**SITE PLAN FOR THE  
HURRICANE ISLAND REACH**

**DREDGED MATERIAL MANAGEMENT PLAN  
WITH INTEGRATED ENVIRONMENTAL ASSESSMENT**

**POOL 11  
DUBUQUE COUNTY, IA AND GRANT COUNTY, WI  
UPPER MISSISSIPPI RIVER, RIVER MILES 591-608**

**APPENDIX D**

**Figure 10.** Elevations at Preferred Bathtub Site

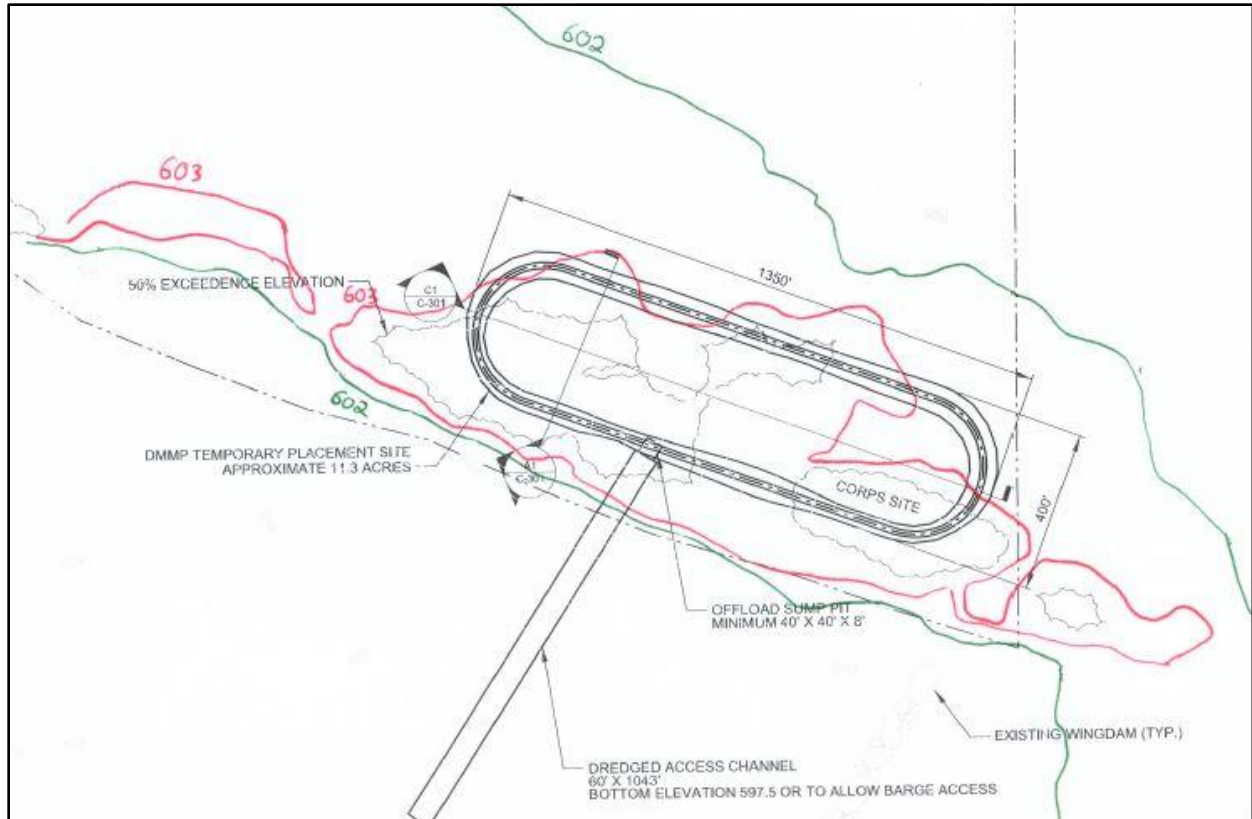
**Comment (Bathtub Site-site specific):** The Department recommends the footprint of the entire bathtub site be shifted to the east to remove the upstream end of the containment berms from extending into the backwater channel.

Question: Was the hydrographic data depicted in Figure 10 corrected for river stage?

**Response:** It is understood that this concern is based on orthoimagery showing the proposed bathtub site in relation to the existing island mass. The orthoimagery was taken at a snapshot in time when water elevations may not adequately convey the topography of the island and surrounding river. Using contours of the area, the elevation on the northwest edge of the bathtub is considerably flat and does not vary significantly. Survey data shows the portion of the containment berm in question would be constructed at a location with elevation higher than 602ft MSL1912, and thus is less than 1 foot below flat pool of 603ft (Figure 10).
